February 12, 2021

Joshua Wayland, PhD
Surface Transportation Board
c/o ICF
9300 Lee Highway
Fairfax, VA 22031
Attention: Environmental filing, Docket No. FD 36284

Re: Draft EIS Comments on Uinta Basin Railway

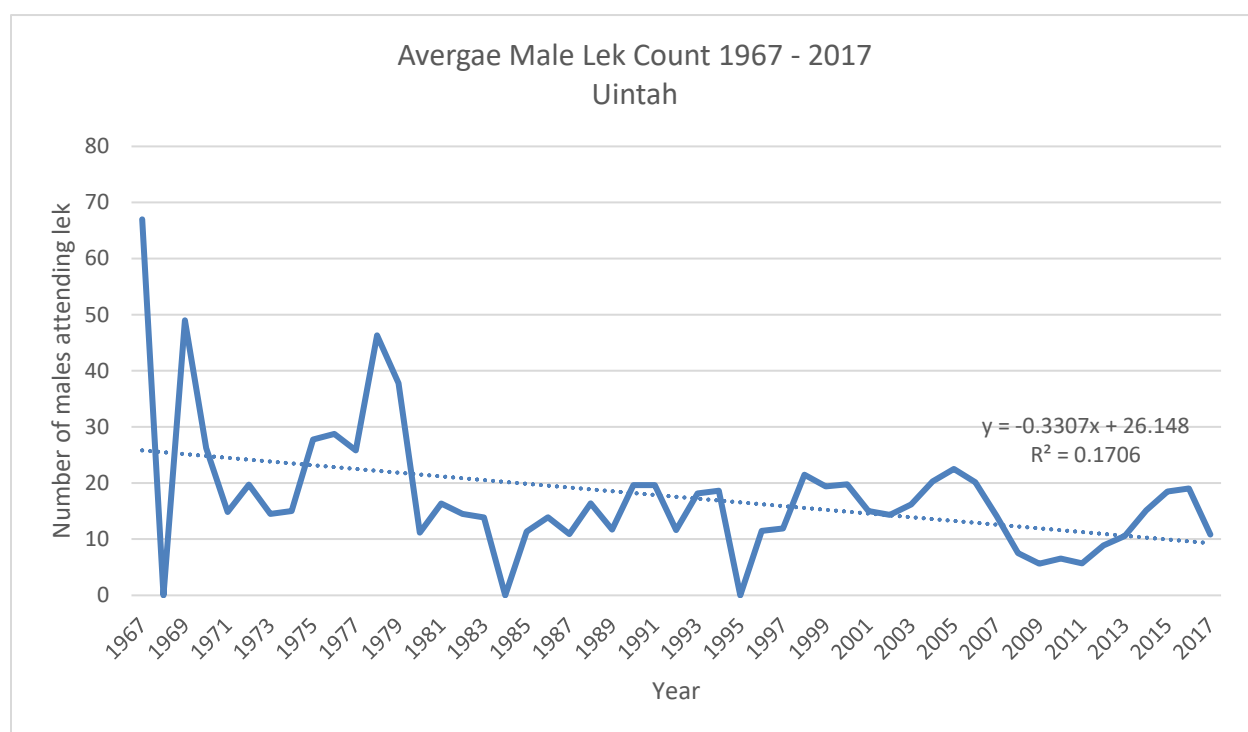
Lek data provided by the Utah Division of Wildlife Resources indicate that the negative trend for the Emma Park sage-grouse meta population continues for the years 2017 through 2020 (the years after the above chart was created), with the 2020 lek count across the 11 leks down over 40% compared to the 2017 count.
